RESPONSE TO TR RAIS FROM ERG

Response TR RAI-3.1-1 (TR Section 3.1.3.1, Section 3.1.4, Section 3.2.12 and Section 4.1.2)

Figure 4.2-1: Dewey Pivot Areas

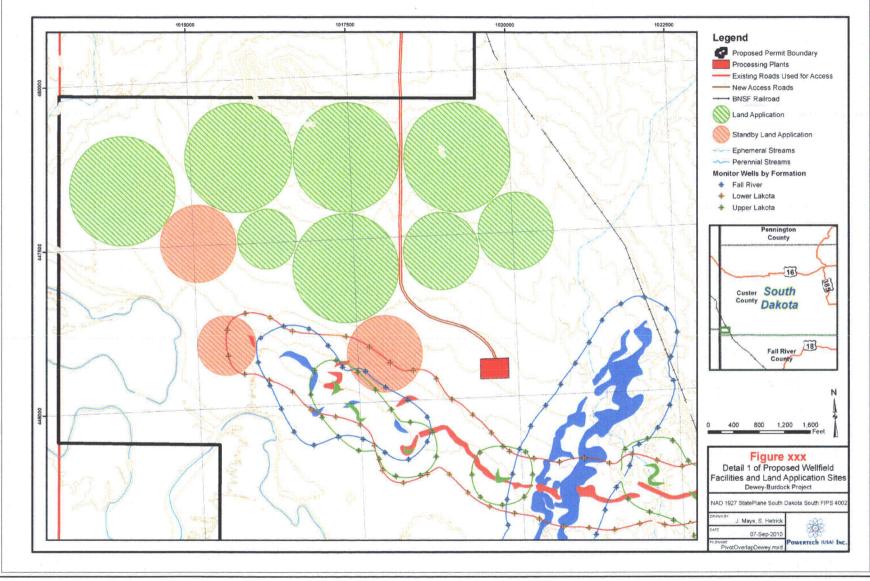
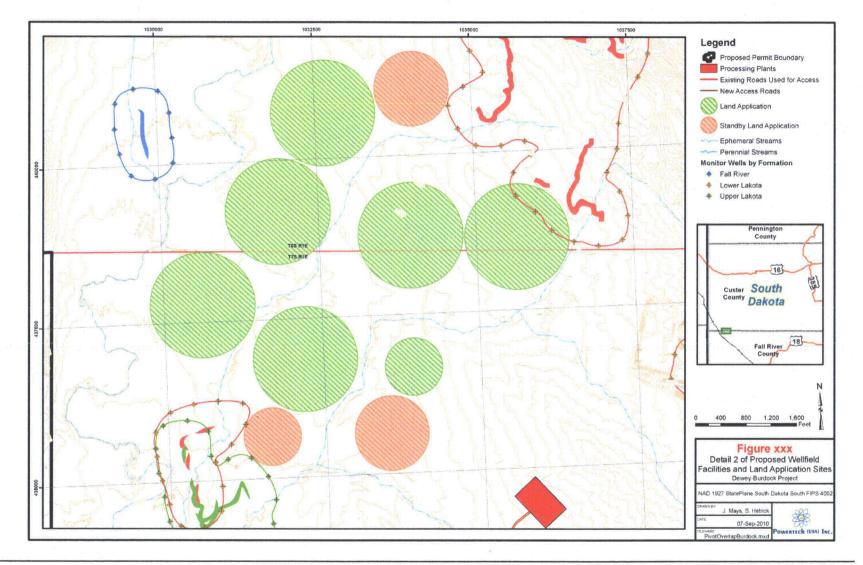
On Supplemental Exhibit 3.1-4, various land application areas overlap outlines of two future mine units. Please confirm the location of the land application areas. If the land application areas overlap proposed well fields, please provide further information regarding the manner in which both the well field and land application areas will be operated.

Minimal overlap occurs within the Dewey pivot areas designated for "standby". Please refer to attached figures 4.2-1 and 4.2-2 for details. Production, injection and monitoring wells may be operated (when properly sealed to prevent subsurface contamination and sampling cross-contamination) within actively irrigated pivot areas. The wells will also have sufficient casing above grade to ensure proper access to the wells and that the wells are unaffected during times of irrigation. There are no anticipated issues with operating the pivot areas within this small portion of a well field. Irrigation nozzles are suspended above the well head covers and the supporting wheels of center pivot piping can be positioned to pass between wells. These standby pivot areas are expected to be reserved for use only when the underlying well field is not active and to serve as a contingency to the primary pivot areas.

Figure 3.1-7: Water Balances for the Dewey-Burdock Project

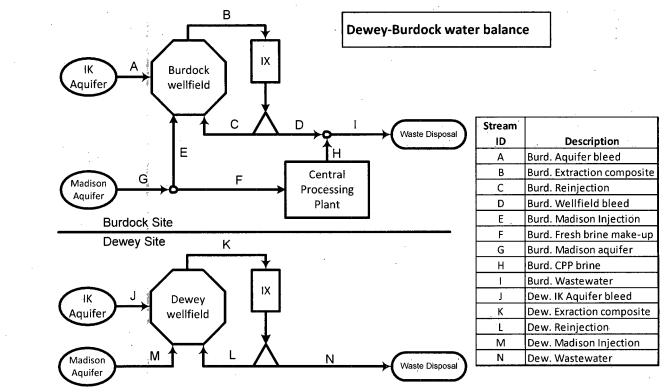
The application did not include a water balance diagram consistent with the guidance in Section 3.1.2 of NUREG-1569. Please provide a water balance diagram.

The water balances at both the Burdock site and the Dewey site for the recovery phase, the restoration phase with 1% bleed, and the restoration phase with one (1) pore volume of bleed are presented in Figure 3.1-7 (attached). Typical flow rates are provided for both the deep well disposal option, in which the groundwater treatment restoration method is utilized, and the land application disposal option, in which the groundwater sweep restoration method is utilized.

For recovery operations, the water balance flow rates are identical for both disposal options, producing, for a recovery bleed of 0.875 percent of the groundwater extraction rate, approximately 32 gpm of wastewater at the Burdock site and 15 gpm of wastewater at the Dewey site.

Figure 5.7-10 Proposed Air Particulate Sampling Locations

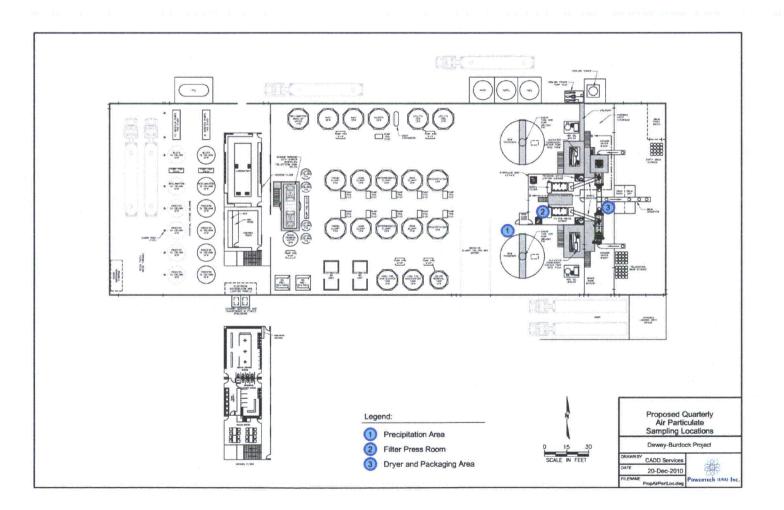
a. Consistent with NUREG-1569, Acceptance Criterion 5.7.3(1), please provide facility drawings that depict the facility layout and the location of samplers for airborne particulates.

Figure 0-1: Locations of Radon Decay Product (Radon) Monitors on-site of Satellite Facility, Outside the Satellite Facility

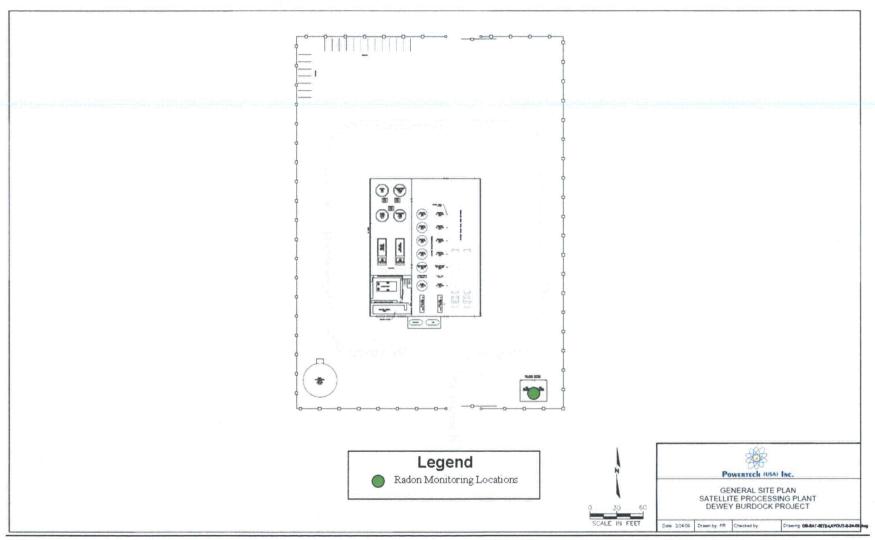
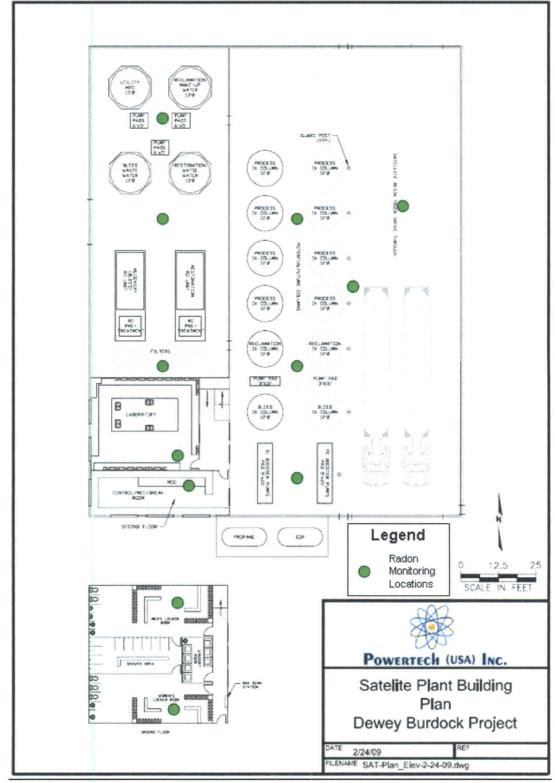
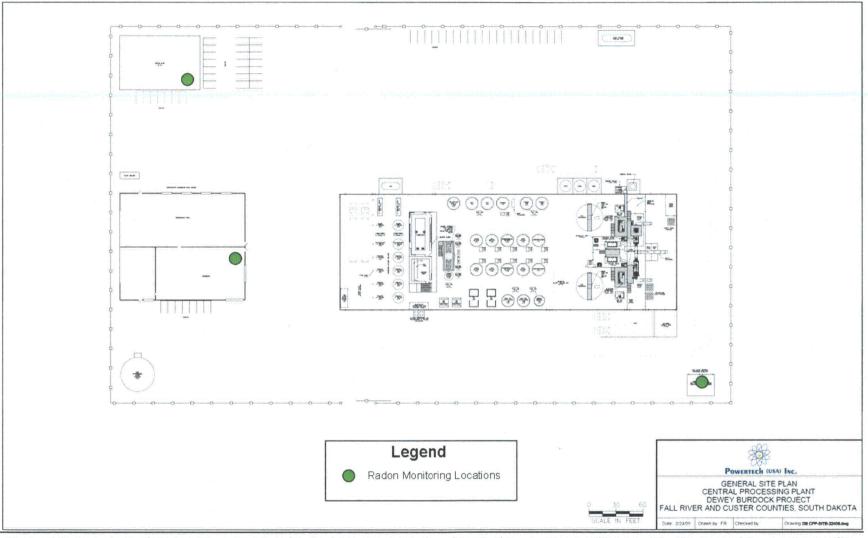
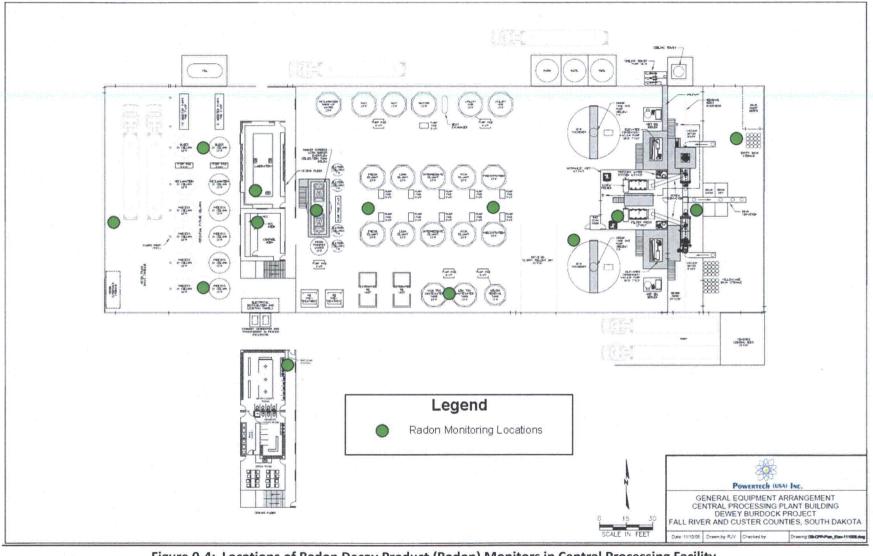
Figure 5.7-10 does not indicate locations of radon monitors. Consistent with Regulatory Guide 4.14 and NUREG-1569, Acceptance Criterion 5.7.7.3(2), please provide this information.

Figure 5.7-6, Figure 5.7-7, Figure 5.7-8, and Figure 5.7-9 show the designated radon monitoring locations.

Figure 5.7-11: Operational Environmental Sampling Locations

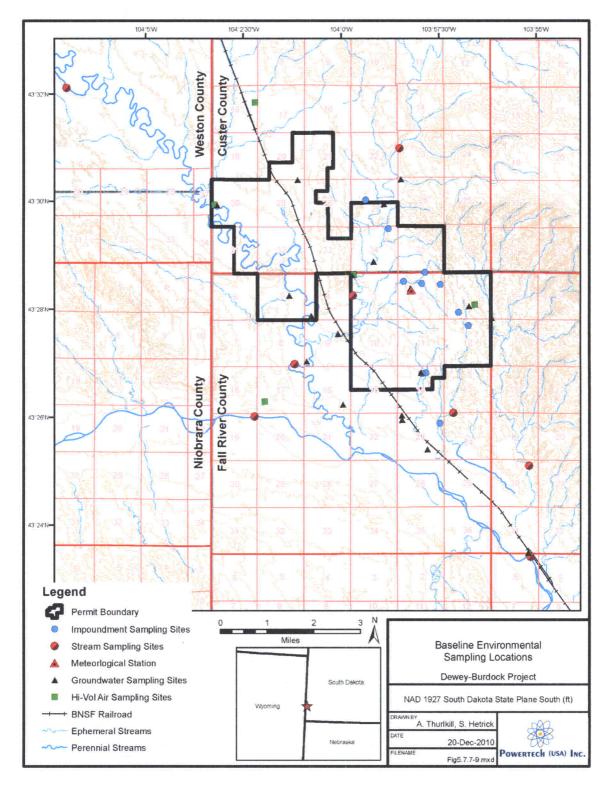
However, in Section 5.7.8 of the TR, the applicant identified only 11 impoundments in its operational surface water monitoring program as shown on Figure 5.7-10 of the TR. In addition, the applicant has not identified sampling locations for Beaver Creek which passes through the mill site. The applicant should analyze all surface water features in accordance with Regulatory Guide 4.14 criteria, including offsite water features that could be impacted from operations, or provide a justification for an alternate methodology that complies with 10 CFR 40, Appendix A, Criterion 7.

The applicant has further analyzed all surface water features in accordance with RG 4.14 and 10 CFR, Appendix A, Criterion 7. As a result the applicant is presenting TR Figure 5.7-11 in support of a modified surface water monitoring plan.

The locations are proposed for the construction phase and first year of operations. The proposed locations are based on some existing monitoring locations developed during site characterization to the extent the locations meet the stated objectives in 10 CFR Part 20, Appendix A, Criterion 7. To further comply, three new stations have been added (LA-01, Onsite, and CHR/BVC). Station PSC01 has been replaced with the "Onsite" station located at the confluence of Pass Creek and ephemeral drainages near the project boundary.

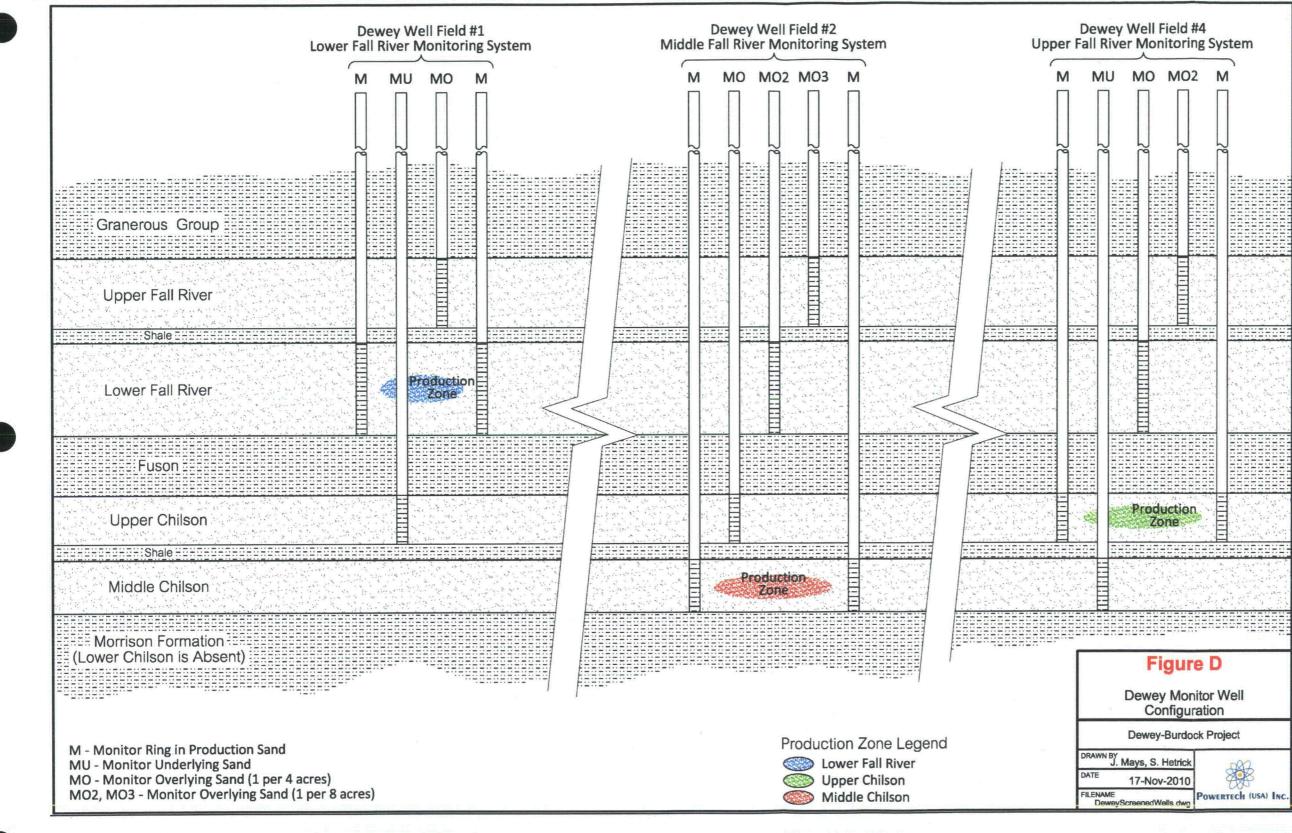
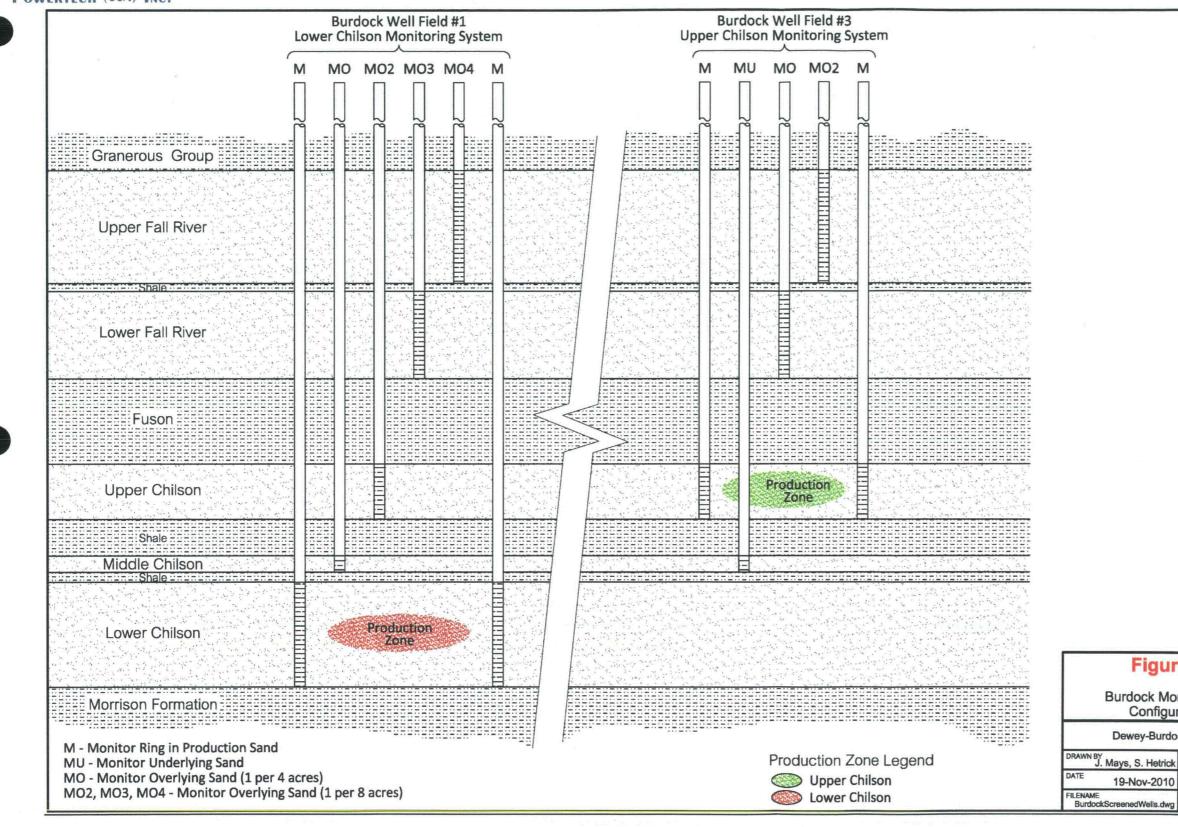
Exhibit 3.1-6 and Exhibit 3.1-7 of the TR Supplement show perimeter monitoring wells farther than 400 feet from several of the proposed production areas. For example, the perimeter monitoring wells shown in Exhibit 3.1-7 are approximately 400 feet from the proposed production in the L2 horizon, but up to approximately 1,400 feet from the proposed production at the L3 horizon. Please justify the variation in well spacings.

The attached Figure B shows the monitoring configuration of a production zone in the Upper Chilson in the Burdock area, Burdock well field #2. When this second production zone is developed, there is expected to be some MO2 wells associated with the first well field developed in the Lower Chilson within its perimeter monitor ring. When injection is started, use of these wells for monitoring will cease. However, all other monitor wells for the Upper Fall River, Lower Fall River, Upper Chilson, and Middle Chilson associated with the Burdock well field #1 will remain in use.

The attached Figure D shows the monitoring configuration of two associated additional productions zones, Upper Chilson and Lower Chilson, underlying the initially-developed Dewey well field #1 in the Lower Fall River. In these cases, where the production zone is already present in the immediately overlying aquifer, MO wells associated with the underlying well field in the Upper Chilson, Dewey well field #4 will not be installed within the perimeter monitor ring of the well field #1. However, outside of the perimeter monitor ring for Dewey well field #1 there will be MO wells associated with Dewey Well field #4. Additionally, MO2 wells associated with the underlying well field in the Lower Chilson, Dewey Well Field #2, will not be installed within the perimeter monitor ring of the overlying Dewey Well field #4. However, outside of the monitor ring for the well field in the Upper Chilson there will be MO2 wells associated for the Dewey Well field #2 within the Upper Chilson. Additional the same pattern will follow for MO3 wells associated with Dewey Well field #2, which will be excluded only within the perimeter monitor ring for Dewey well field #1.

It should be noted that if the Middle and Lower Chilson become a single hydrogeologic unit then these are treated as one unit for purposes of monitoring. If they are separate units within the entire area of the perimeter monitor ring of the well field, than they will be treated as separate hydrogeologic units and monitored separately.

Figure 2.7-19: Operational Groundwater Quality Quarterly Sampled Wells

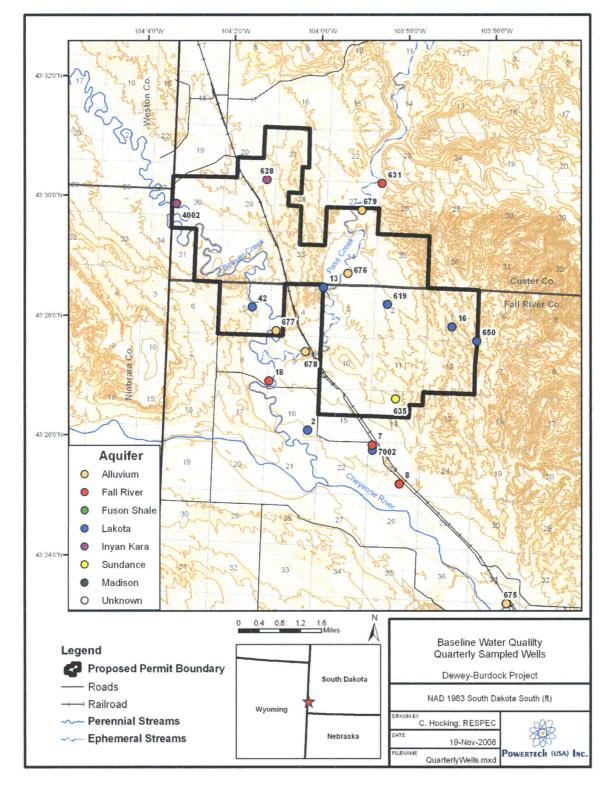
Section 5.7.8 of the TR states, "Quarterly samples will be collected from drinking water and livestock wells, included in the groundwater sampling sites as shown in Figure 5.7-10." This statement implies there are more proposed well sampling locations than what is shown in Figure 5.7-8. NRC staff notes that numerous Inyan Kara wells in Appendix 2.2-A are close to well fields within the license boundary and are not included in Figure 5.7-10. Please specify all water well sampling locations.

All well sampling locations are depicted on attached TR Figure 2.7-19.

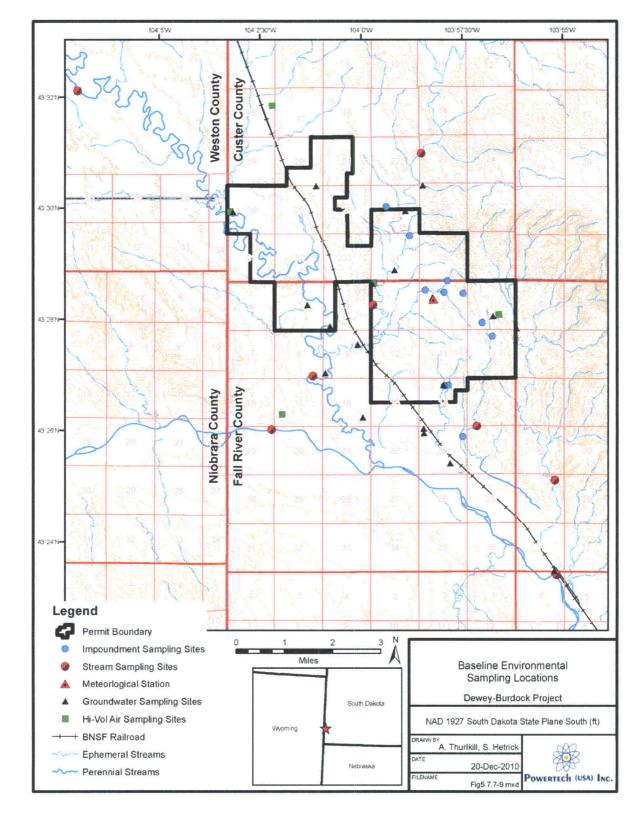
a. NRC staff notes that surface water sampling locations indicated in Section 5.7.8 and Figure 5.7-10 of the TR do not include an upstream location for Beaver Creek and a downstream location for Pass Creek where it exits the site. Consistent with Section 5.7.8.3 of NUREG 1569, please include the above-referenced surface water sampling locations.

The attached TR Figure 5.7-11 shows all environmental monitoring sites. The scale of the map has been adjusted to depict all surface water sampling locations upstream of PAA and downstream of PAA.

Figure 6.1-1: Schedule for Proposed Well Field Operations

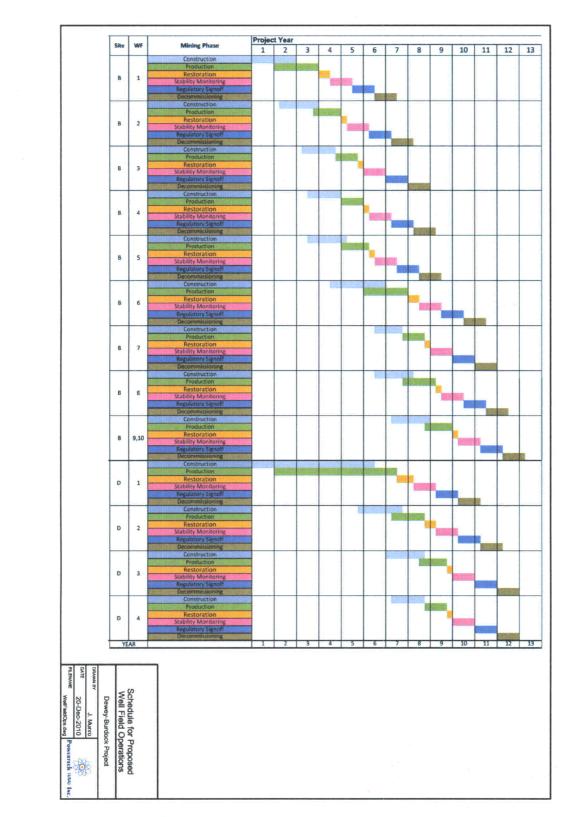
The applicant's general schedule did not provide a timetable for restoration of individual well fields. This detailed information as well as other information such as the requirement for NRC notification of the termination of principal activities or an alternate schedule, needs to be included in the TR consistent with Section 3.1.1 (4) of NUREG-1569 and in accordance with requirements of 10 CFR 40.42. Please address this comment.

The revised well field schedule is shown in attached Figure 6.1-1. As illustrated on this figure, it is expected that the aquifer restoration phase for each well field will be completed in less than two years. Should restoration efforts indicate a period longer than 24 months are necessary for restoration of a particular well field, Powertech (USA) will request NRC approval for the modification as an alternate schedule.
